Technical Service Bulletin

00 Engine shuts off and/or EPB activates when driver door is opened

00 13 51 2031850/4 July 12, 2013. Supersedes Technical Service Bulletin Group 00 number 13-46 dated March 13, 2013 for reasons listed below.

Figure 1. Old Start-Stop glovebox insert.

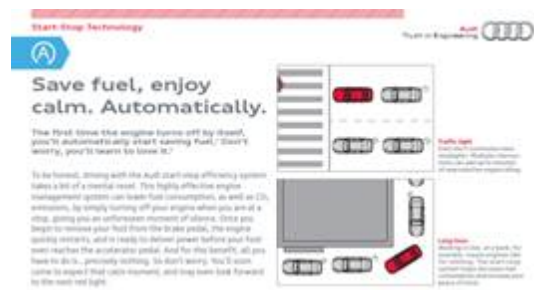
4. If available, replace the old Start-Stop glovebox insert (Figure 1), with the new glovebox insert **BR-12-631-US** (Figure 2). Additional inserts may be ordered from the Brand Store.
